# Map Update Report

## MR029 Drogheda

<b>PROJECT</b>	Drogheda Map Update
<b>PROJECT NO.</b>	MR029
<b>PROJECT ENGINEER</b>	Kevin Macken
<b>DOCUMENT TITLE</b>	Drogheda Map Update Report

Figure 2-1; Overview of Map Update Watercourse

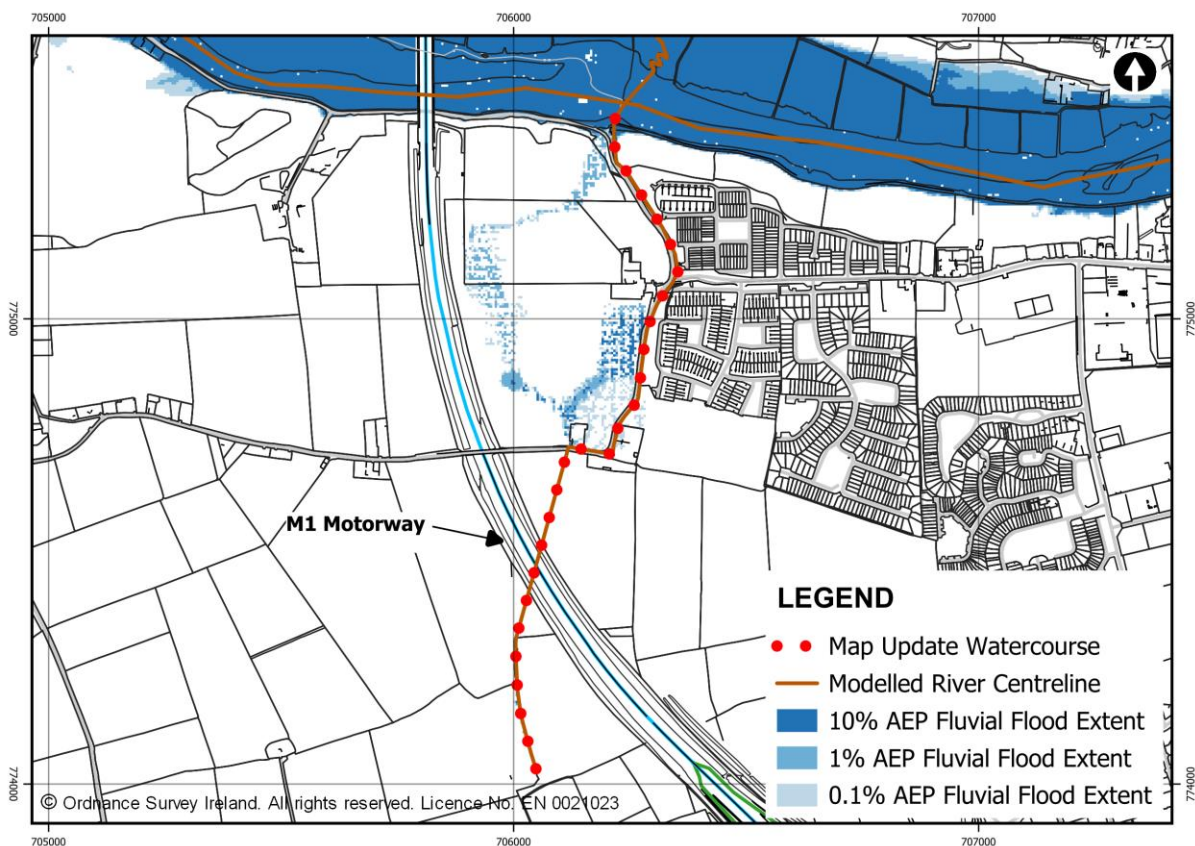
A flood map review request was received which noted that a watercourse near Drogheda that had been included in the CFRAM study was no longer in existence. During the CFRAM project, the watercourse was shown crossing the M1 motorway, before flowing northwards into the River Boyne east of the M1 Bridge on the River Boyne (Mary McAleese Boyne Valley Bridge) see Figure 1-1. The flood map review request indicated that the watercourse was intercepted by the drainage associated with the M1 motorway.

Figure 3-1; 1% Model Node Results

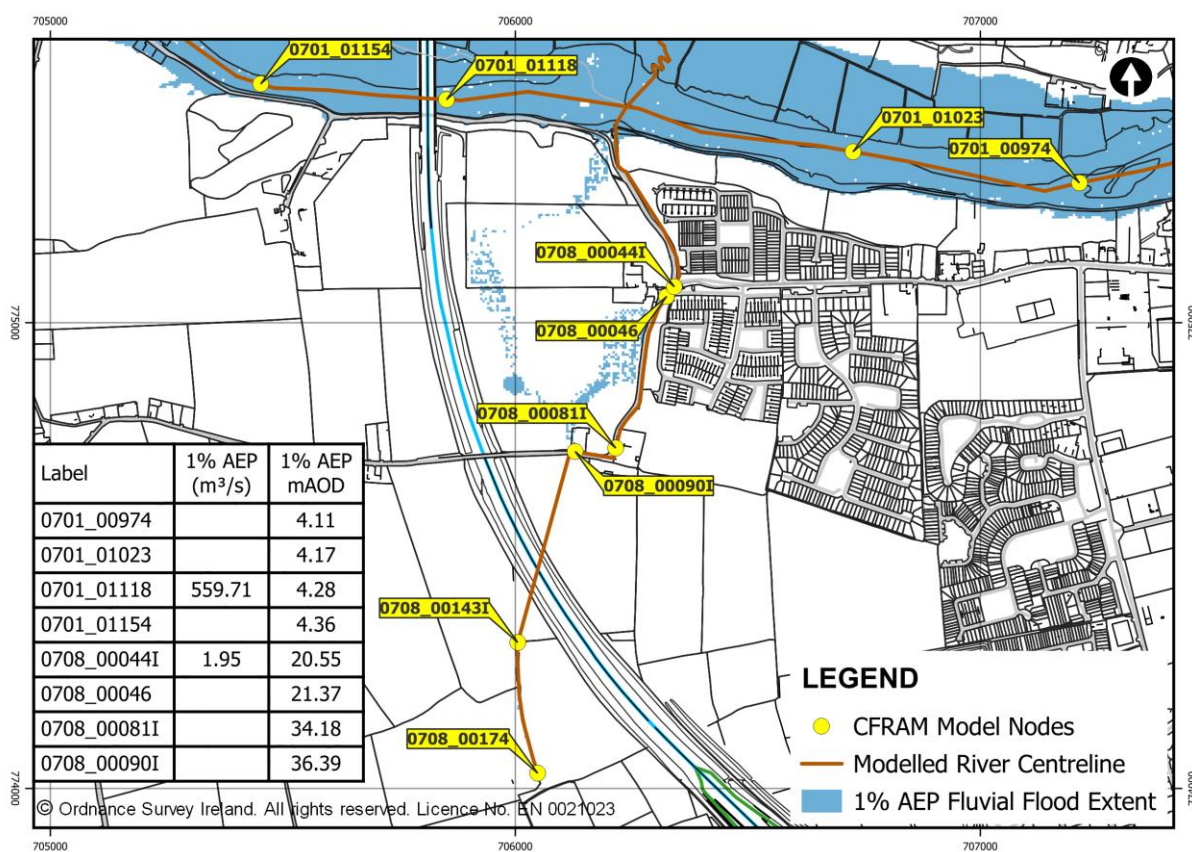
The process of updating the Flood Maps to account for the now diverted watercourse requires an understanding of its interaction with the River Boyne. The 1% AEP flows are shown in Figure 3-1 for selected nodes. The flow in the River Boyne at the confluence is approximately 559.7 m<sup>3</sup>/s, while the flow in the Map Update Watercourse is approximately 1.5 m<sup>3</sup>/s at the confluence. The Map Update Watercourse represented just 0.3% of the overall flow in the River Boyne. Removal of such a small amount of flow would be imperceptible if the hydraulic model was updated to reflect this.

Although the flow in the watercourse is insignificant, the watercourse itself could act as a pathway for flood waters from the River Boyne. Both Figure 3-1 and Figure 3-2, show the 1% AEP water levels of the Map Update Watercourse. Figure 3-2 shows that the slope of the Map Update Watercourse is significant and there is limited ingress possible for flood waters from the River Boyne. The elevation of the 1% AEP water levels is over 15 m just 400m from the confluence with the River Boyne. The 1% AEP levels in the River Boyne are approximately 4.28 mAOD at this location.

Figure 3-3; LiDAR Overview

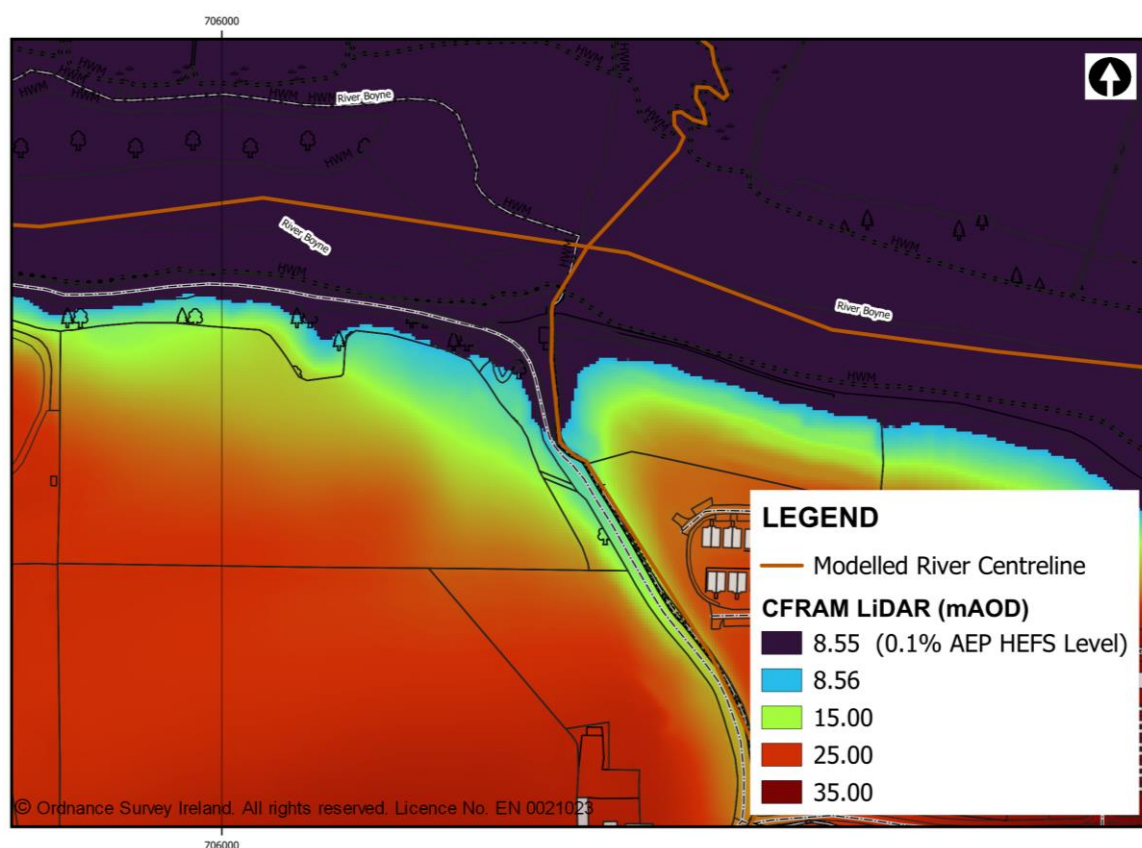
The most extreme event considered by the CFRAM study is the High End Future Scenario (HEFS). The water level predicted by River Boyne in this location is 8.55 mAOD. Figure 3-3 uses LiDAR data to illustrate the change of elevation in the area. The navy contour shown on Figure 3-3 estimates the 0.1% AEP HEFS flood extent with the Map Update Watercourse removed; the navy contour is only shown near the confluence with the River Boyne and is not shown on the watercourse itself.

Given that the flood flows associated with the Map Update Watercourse are negligible and the long profile and LiDAR analysis indicates that the watercourse does not permit floodwater ingress from the River Boyne, there is no need to re-run the hydraulic model with the watercourse removed.

Figure 3-4; Area to be Removed from Flood Maps

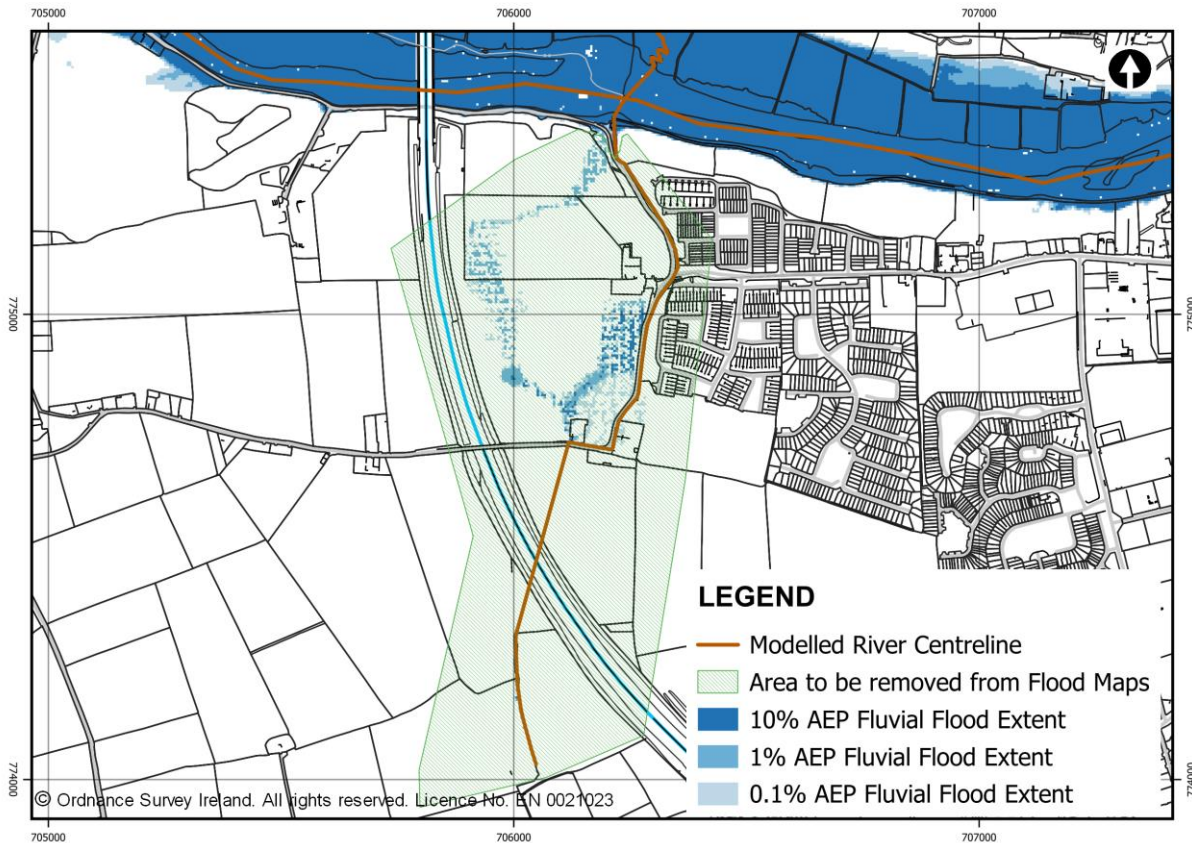
Using the HEFS flood level in the River Boyne and LiDAR, a polygon has been drawn which creates a boundary between flooding associated with the River Boyne and the Map Update Watercourse. This is shown in Figure 3-4 with the current 10%, 1% and 0.1% AEP fluvial flood extents. All flooding showing within the hatched area is to be removed from the Flood Maps.

Figure 3-5; Updated Flood Map

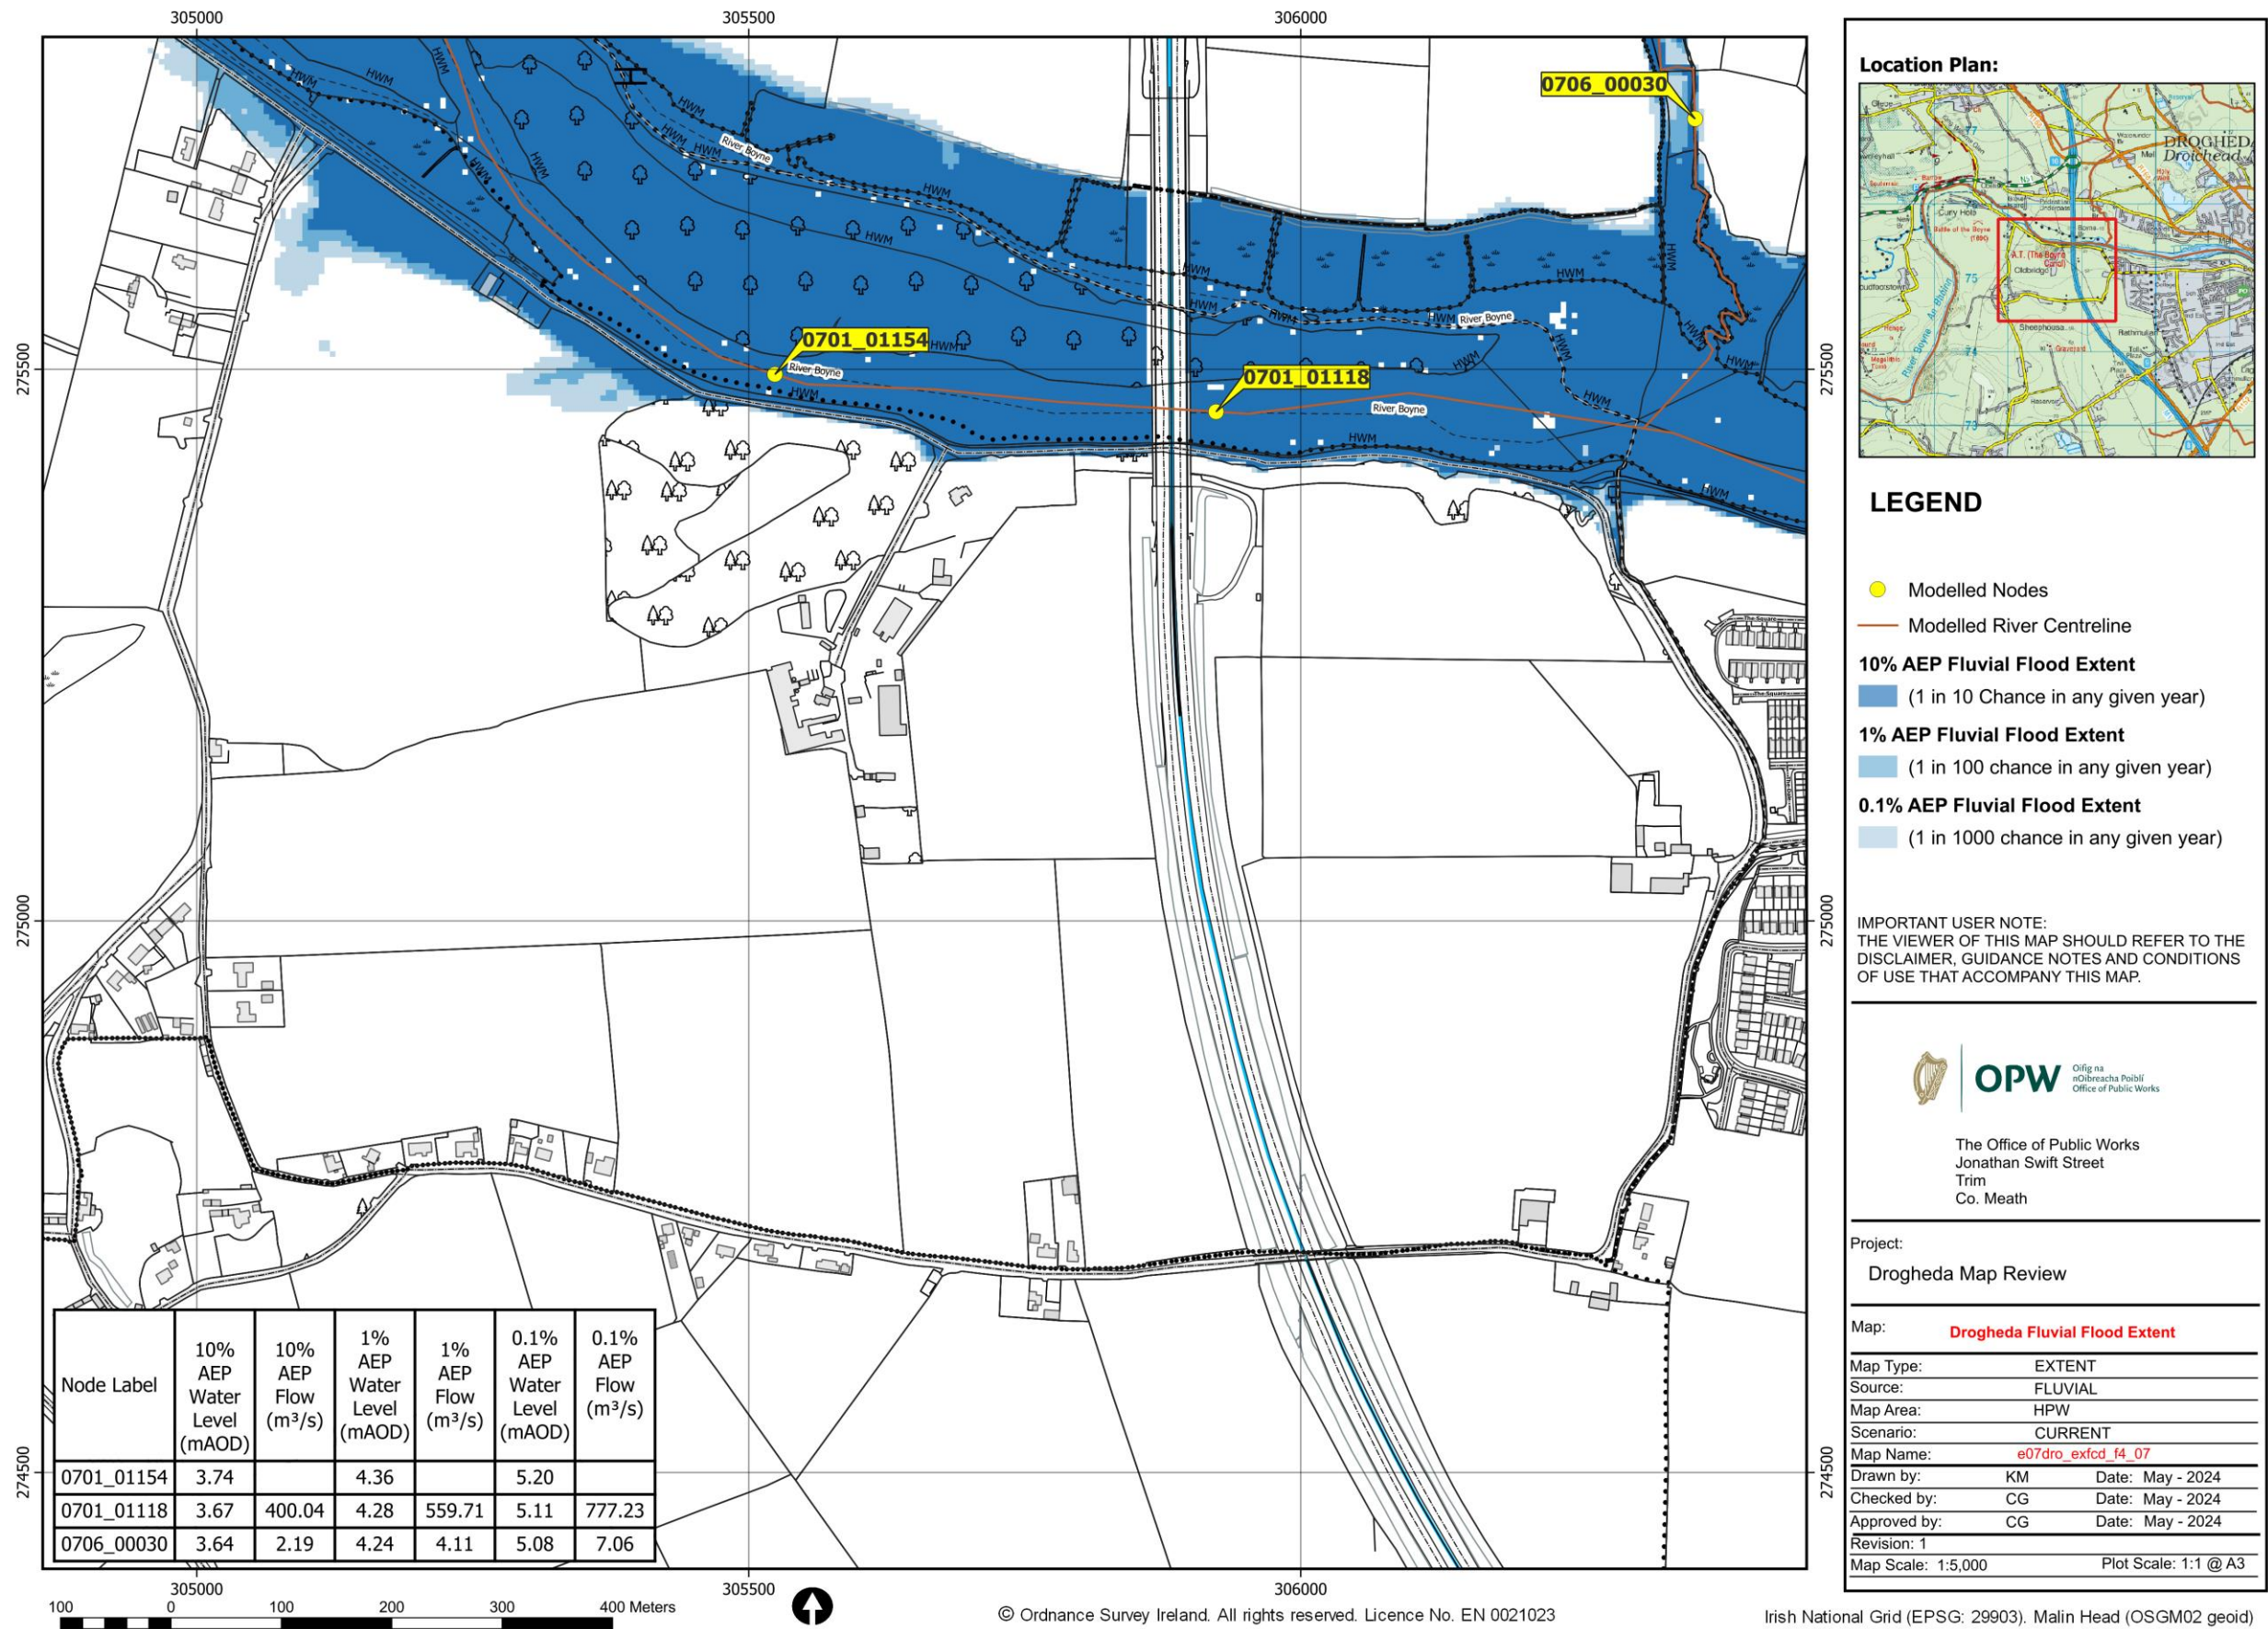
The Maps have been updated to reflect the diversion of the watercourse into M1 Drainage network. An analysis of the hydrology, hydraulics and gradient of the Map Update Watercourse has indicated that its removal would not have a material effect on the flood extents in the River Boyne. The updated flood map is shown in Figure 3-5.
